Project	<b>IEEE 802.16 Broadband Wireless Access Working Group</b> < <a href="http://ieee802.org/16">http://ieee802.org/16</a> >		
Title	<b>Physical Layer Design Based on Fixed Subcarrier Spacing for Greenfield Deployment without Legacy Support</b>		
Date Submitted	<b>2010-07-07</b>		
Source(s)	Sean Cai, Mary Chion, Huiying Fang, Bo Sun, Jerry Chow, Yang Liu ZTE Corporation Lei Wang InterDigital Communications	E-mail:	<a href="mailto:scai@zteusa.com">scai@zteusa.com</a> <a href="mailto:Fang.huiying@zte.com.cn">Fang.huiying@zte.com.cn</a>  <a href="mailto:leiw@billeigean.com">leiw@billeigean.com</a>
Re:	IEEE 802.16 Working Group Sponsor Ballot  P802.16m/D6 : 16.3.2.3, 16.3.3, 16.3.5.4.1, 16.3.6.5.1.2		
Abstract	Numerology, Frame Structure, Superframe/Frame configuration and Pilot design based on fixed subcarrier spacing for Greenfield deployment without legacy support		
Purpose	To discuss and accept the proposed solution in this contribution, and adopt the solution text of this contribution into the AWD baseline document IEEE P80216m/D6.doc.

# Physical Layer Design Based on Fixed Subcarrier Spacing for Greenfield Deployment without Legacy Support

**Figure aaa Basic frame structure for FDD mode**

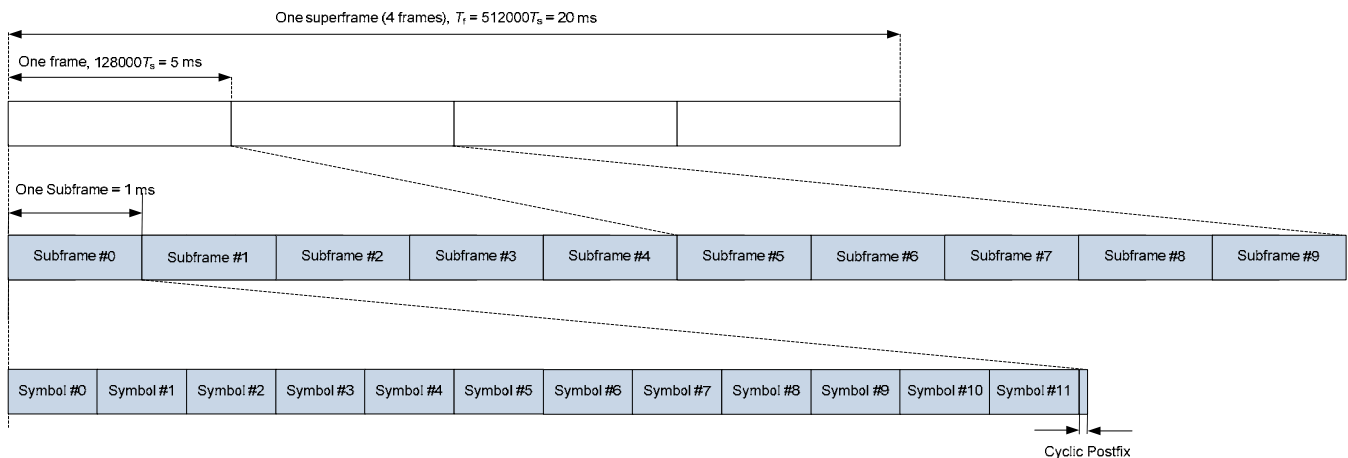
The advanced air interface basic frame structure is illustrated in Figure 465a for FDD mode and Figure 465b for TDD mode. Each 20 ms superframe is divided into four equally-sized 5 ms radio frames. Each 5 ms radio frame further consists five equally-sized 1 ms subframes. According to the different configurations in Table 779a, the number of symbols in a suframe can be different.

**Figure bbb. Frame Structure Type for TDD mode**

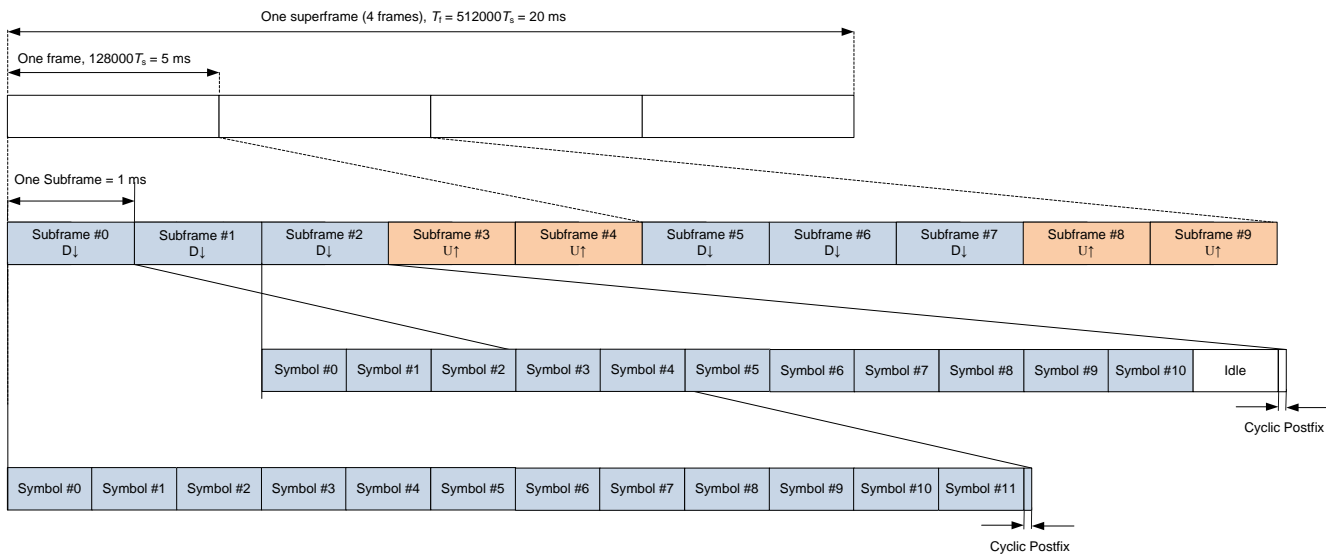
For Type TDD mode, a subframe is also the smallest unit to be configurable for downlink and uplink transmission. As shown in Figure 465a, Subframe# 0 is always reserved for downlink transmission. Starting from Subframe# 1, each subframe can be configurable for downlink or uplink transmission. For each subframe in a radio frame, “D” denotes the subframe is reserved for downlink transmission, “U” denotes the subframe is reserved for uplink transmission. The concept of slots is only used to describe the dimensions of resource blocks.

**Figure ccc Frame structure with special subframe**

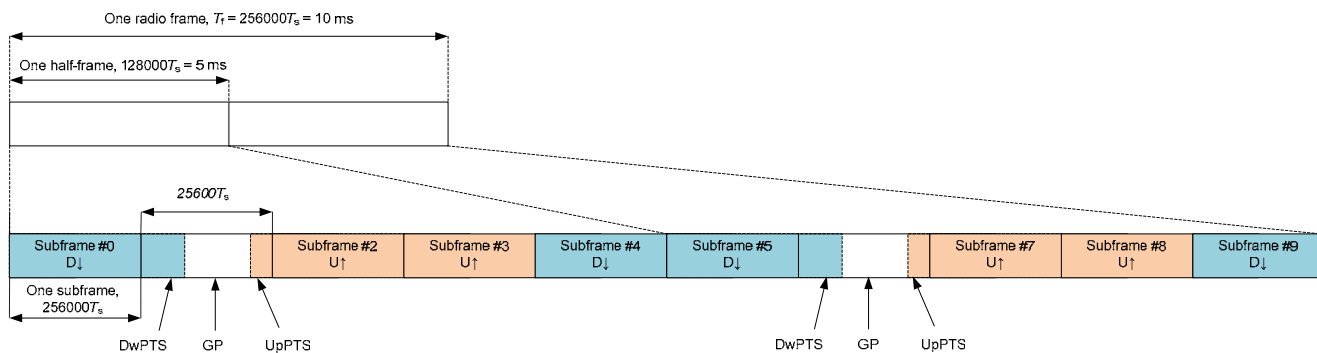
“S” denotes a special subframe with the three fields DwPTS, GP and UpPTS. The length of DwPTS and UpPTS is given by Table 779c subject to the total length of DwPTS, GP and UpPTS being equal to 1 ms. Subframes 0 and 5 and DwPTS are always reserved for downlink transmission. UpPTS and the subframe immediately following the special subframe are always reserved for uplink transmission. In case of FDD, operation with half duplex from UE point of view is supported.

**Figure eee. Pilot patterns for 1 and 2 data streams**

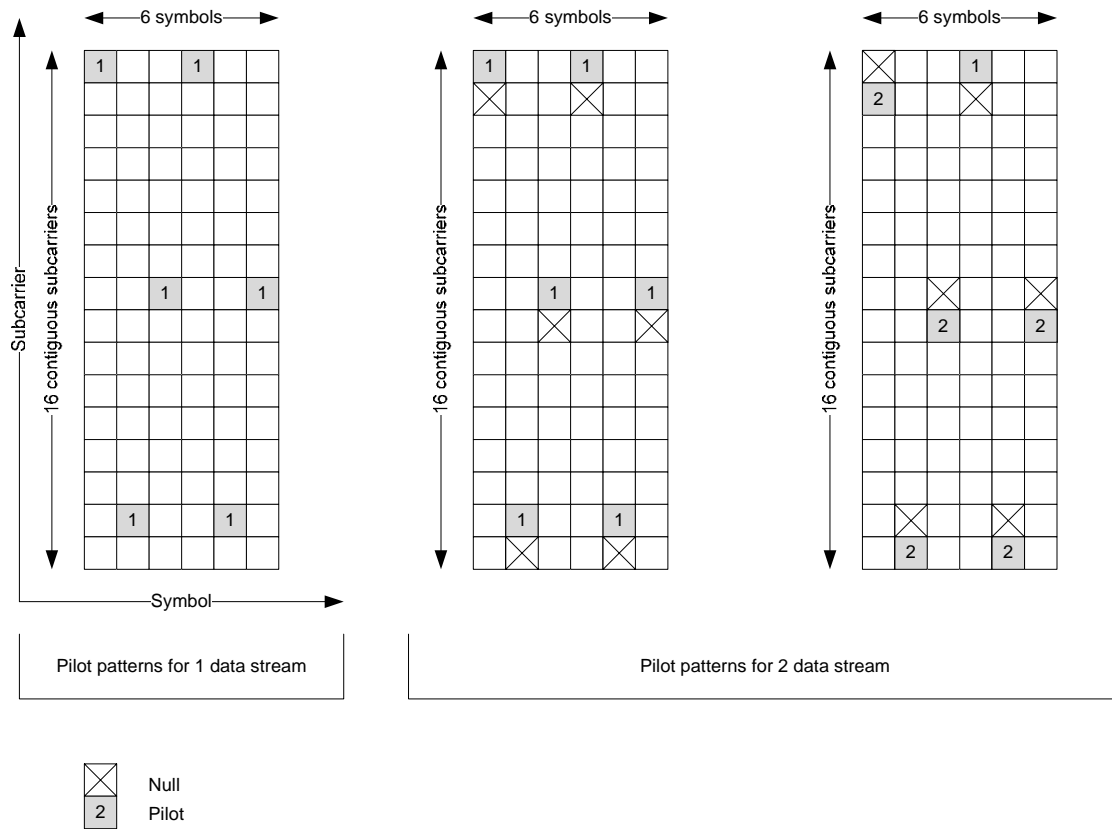
The pilot patterns are specified within a PRU.

**Figure 504d. Pilot patterns for LRU**

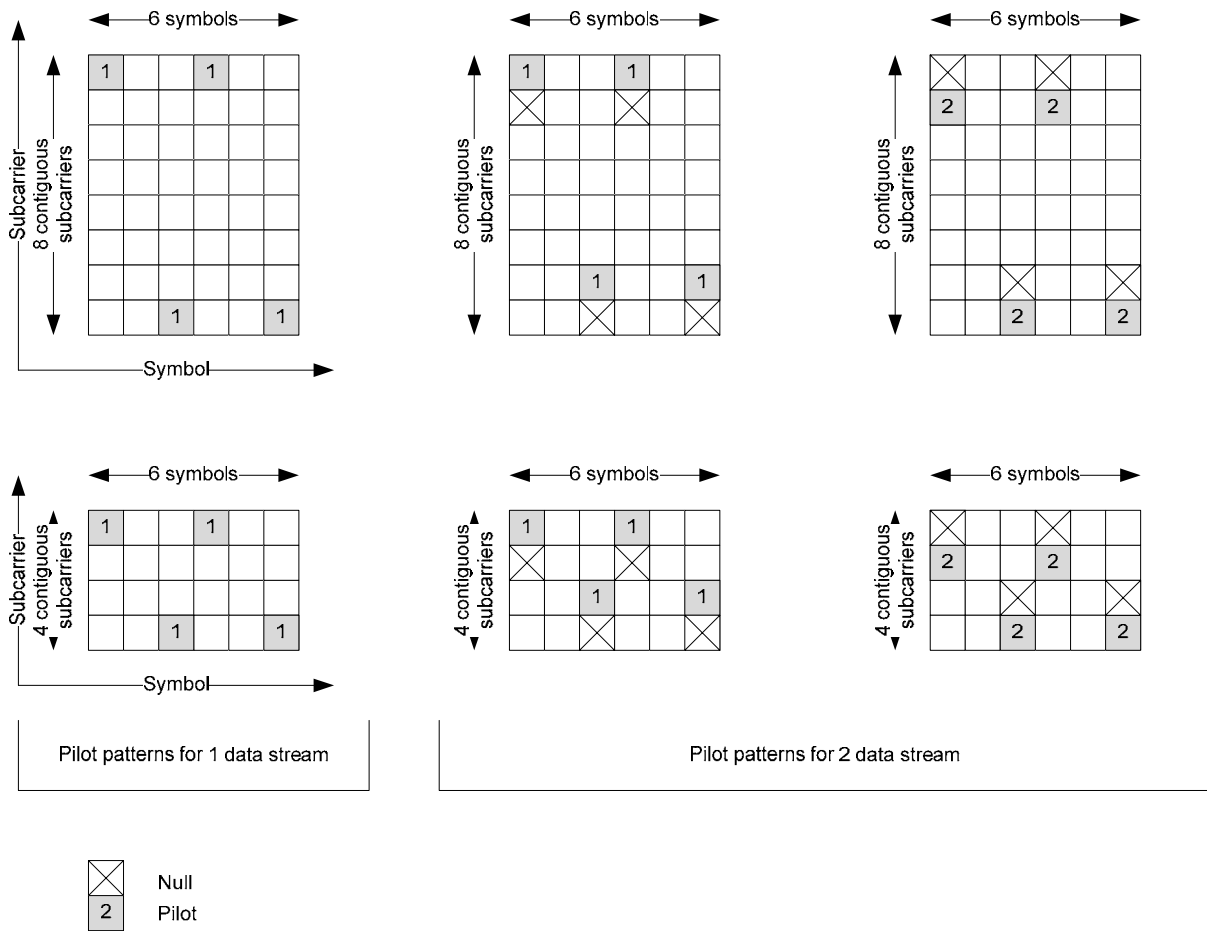
For  $N_{\text{symb}}=5$ , the last symbol of the pilot patterns as shown in Figure kkk, or Figure lll is deleted. Similarly for  $N_{\text{symb}}=3$ , the last three symbols of the pilot patterns are deleted.
